FORD E4OD NEW DESIGN FRONT PUMP FOR 1995 MODELS

CHANGE: Beginning at the Start Of Production for all 1995 model E40D transmissions, Ford Motor Co. introduced an increased displacement Front Pump Assembly, 1.70 cu in/rev, versus 1.50 cu in/rev for previous models.

Figure 1
AUTOMATIC TRANSMISSION SERVICE GROUP

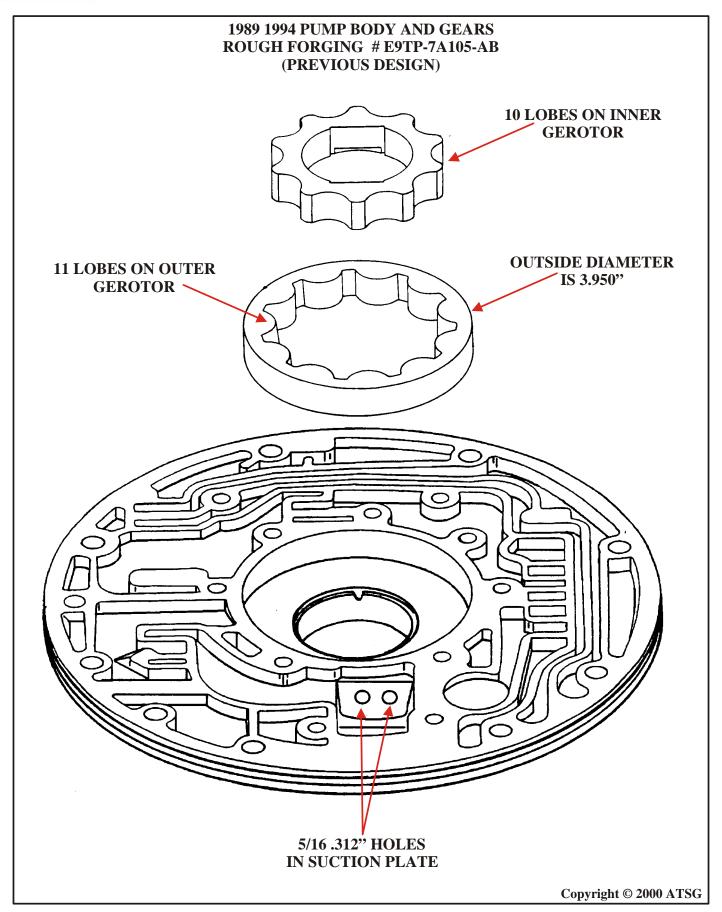
- (1) **FRONT PUMP BODY** Gerotor bore has an increased diameter to accommodate the new design level outer gerotor. Previous outer gerotor diameter was 3.950" and the new design level outer gerotor diameter is 4.083". Refer to Figures 1 and 2. Also, the two holes in the suction cavity were increased from .3 12" to .400", as shown in Figures 1 and 2. Another way to identify the new pump body is with the "Rough Forging Number" F5TP-7A105-AA, and is found on the front seal side of the pump body. All of the oil passages in the new design Front Pump Body remained the same as previous years and are identified in Figure 4.

- (2) **OUTER GEROTOR** The lobes on the Outer Gerotor changed from the previous 11 lobes to 10 lobes on the new design, to accommodate the changes on the inner gerotor. The diameter of the Outer Gerotor also changed from 3.950" to 4.083". Refer to Figures 1 and 2. The changes on both the inner and outer gerotor increased the cavity between the gerotors for 'increased pump volume, as shown in Figure 3.

- (3) INNER GEROTOR The lobes on the Inner Gerotor changed from the previous 10 lobes to 9 lobes on the new design, to accommodate the changes on the outer gerotor. Refer to Figures 1 and 2. The changes on both the inner and outer gerotor increased the cavity between the gerotors for increased pump volume, as shown in Figure 3.

1989 1994 PUMP BODY AND GEARS ROUGH FORGING # E9TP-7A105-AB (PREVIOUS DESIGN)

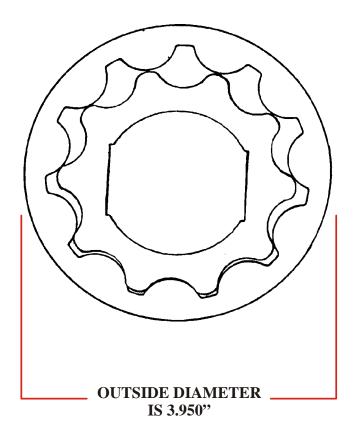
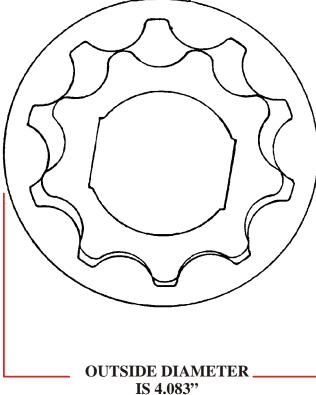
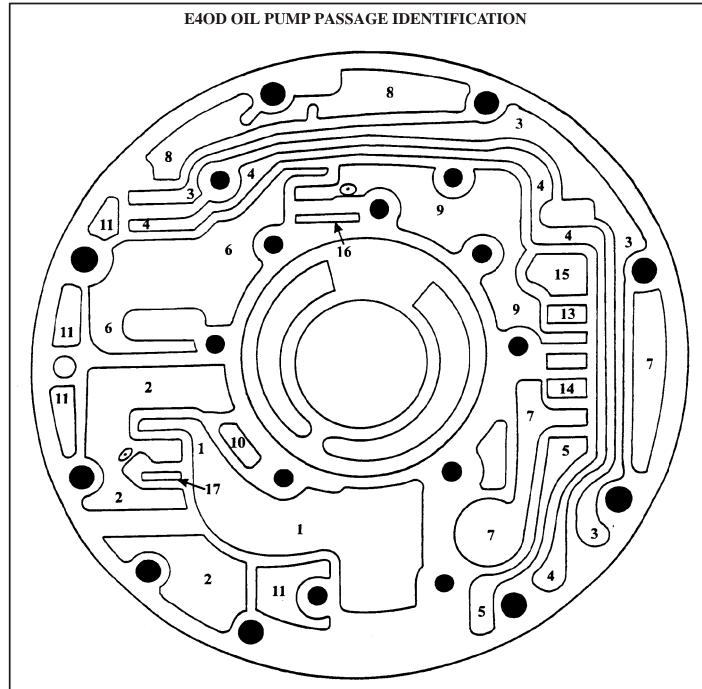
> 10 LOBES ON INNER 11 LOBES ON OUTER

> 9 LOBES ON INNER 10 LOBES ON OUTER
